Housing Authority of the City of Pittsburgh

Glen Hazel Siding Replacement/Door Painting Rebid IFB#600-23-13 Rebid

ADDENDUM NO.1

7 Window Trim Detail
 A2.2 Scale: 1 1/2" = 1'-0"

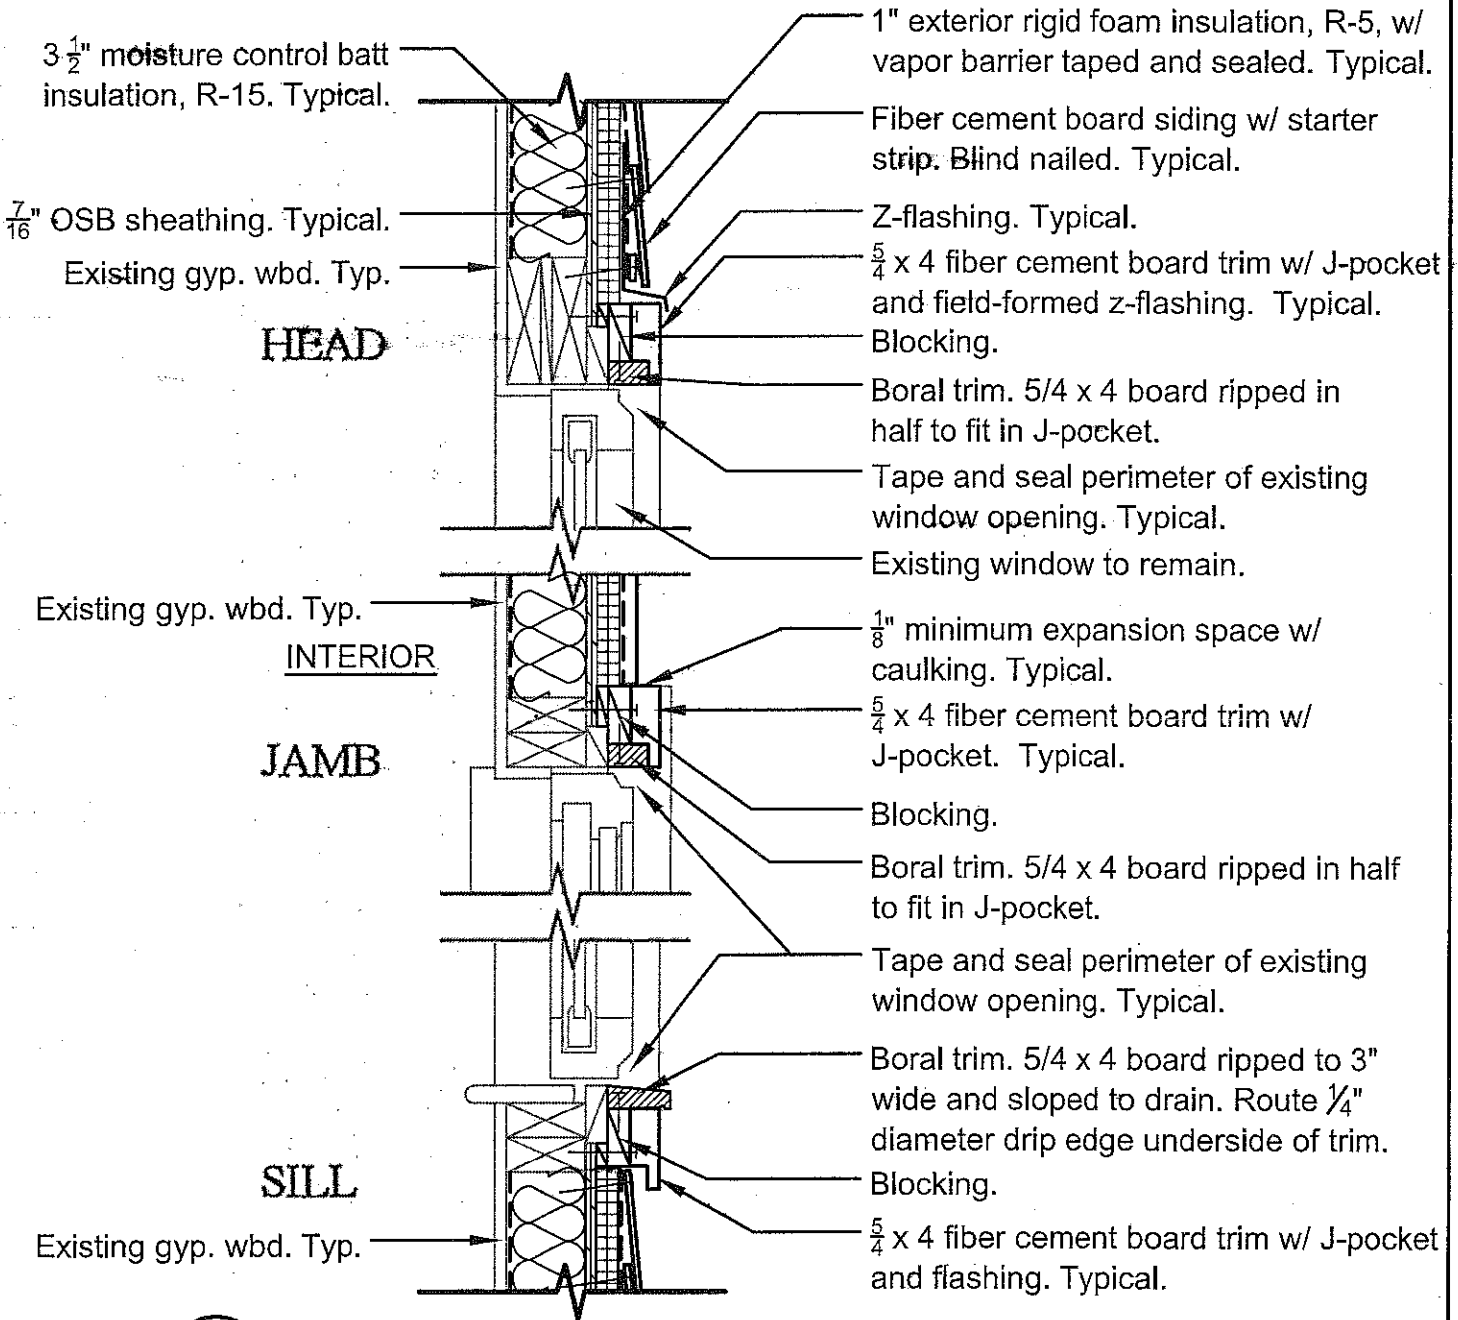
Item 15: Q: Window details - With the addition of the 1" iso and new siding, a recessed window condition is created. Where the window will sit back from the flashings by 1" +. Is that acceptable?

A: See Attachment exhibit A. SK1.1

Note: Typical fiber cement detail. Refer to manufacturer's installation instructions for product-specific instructions.

Note: For Boral Trim information see: www.BoralTruExterior.com. Paint all Boral trim to match adjacent fiber cement trim boards.
 Countersink screws and fill holes with high-grade acrylic caulk or wood filler.
